NASA/TM-2007- 215091
NESC-RP-07-49/07-022-E

DAWN Mission Bus and Waveguide Venting Analysis Review

NASA Engineering and Safety Center Technical Report	Document #: RP-07-49	Version: 1.0
Title: DAWN Mission Bus and Waveguide Venting Analysis Review			Page #: 1 of 36

Figure 7.1-2. Margin Factor of Pressure [ref. 2]

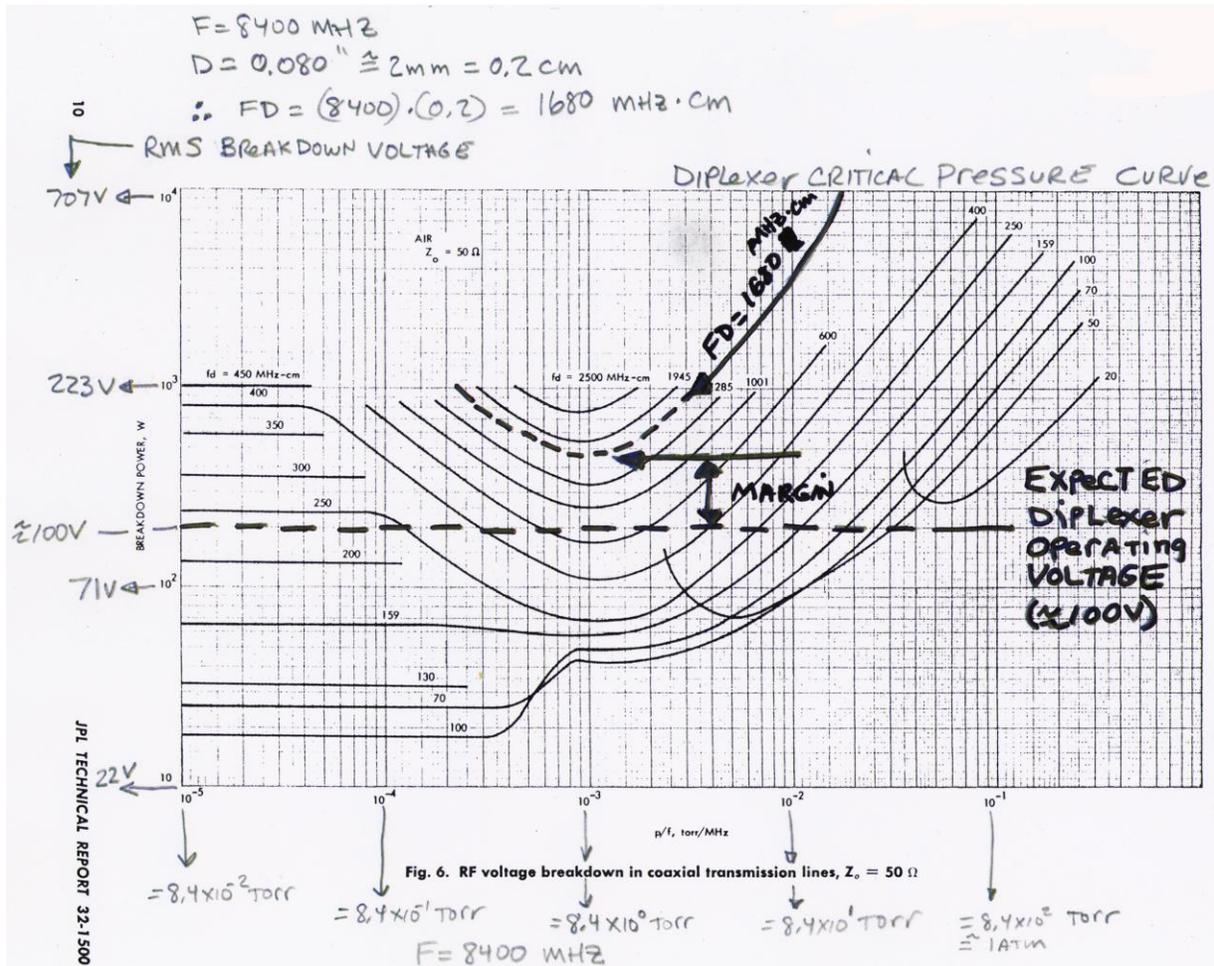
A review of JPL Technical Report 32-1500 (1970) by R. Woo [ref. 3] indicates that the “Critical Pressure” for RF breakdown is about 10^1 Torr. All of the publications and literature on RF breakdown show “Critical Pressure” to be in the 0.1 to 10 Torr region. This suggests a susceptible component one can operate at pressures below the “Critical Pressure” and maintain a margin to corona (move left on the curve) since outgassing constituents (i.e.: easily ionizable electrons) move the curve up or down but not right or left. The DAWN Mission team concluded 10^{-2} Torr is a reasonable upper pressure to operate RF components. This provides from 10^1 to 10^3 margin factor on pressure and an improvement of greater than 6 dB margin on voltage

breakdown as shown in Figure 7.1-2. The breakdown voltage margin will increase further over time as the bus and waveguides continue to vent and the local pressures are less than the "Critical Pressure".

Figure 7.4-5. Diplexer and Isolator Internal Pressure Profile [ref. 4]

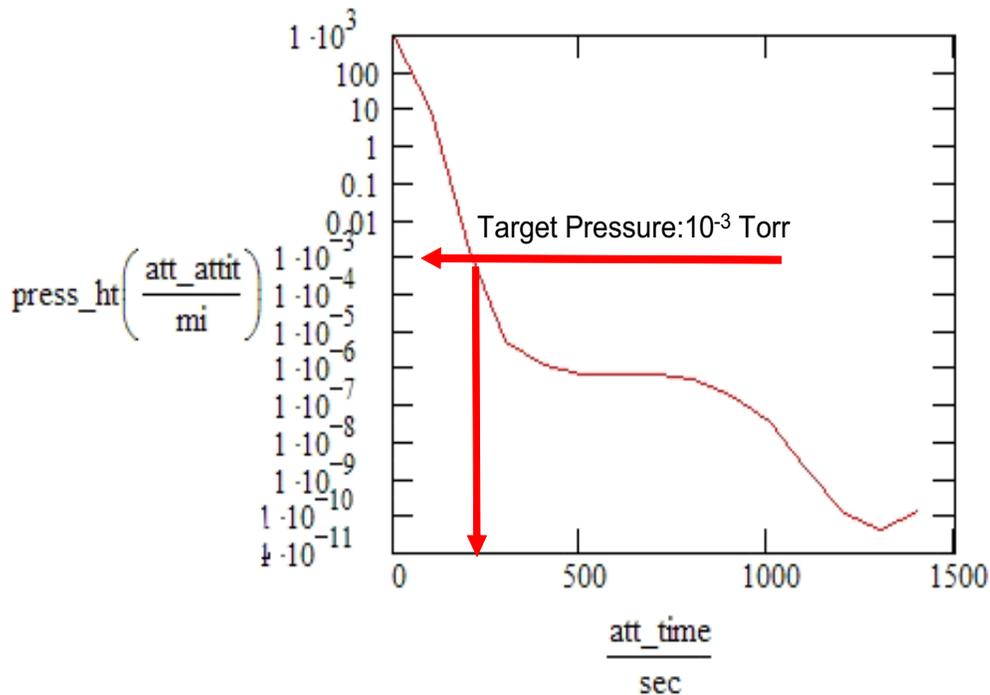
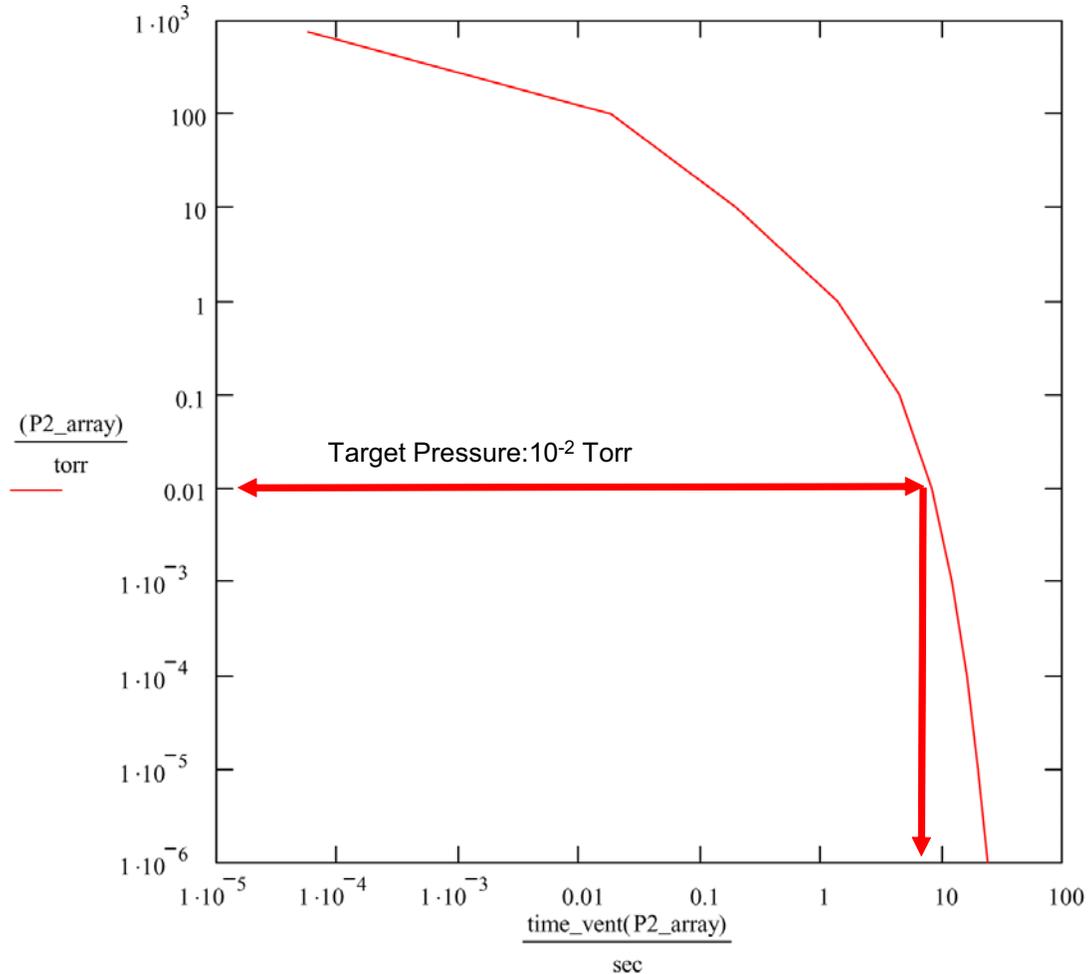
Both of the venting analyses appear correct from atmospheric pressure down to about 10^{-2} or 10^{-3} Torr; 10^{-2} Torr is all that is required for safe activation of the TWTA. It is not clear if the analysis below 10^{-3} Torr, in particular in the neighborhood of 10^{-5} Torr, inside the waveguide is correct since outgassing in a body with small vent holes can require days to complete. This is not a factor for this analysis due to the requirement of 10^{-2} Torr, but curves showing pressures of 10^{-5} Torr and below can cause confusion.
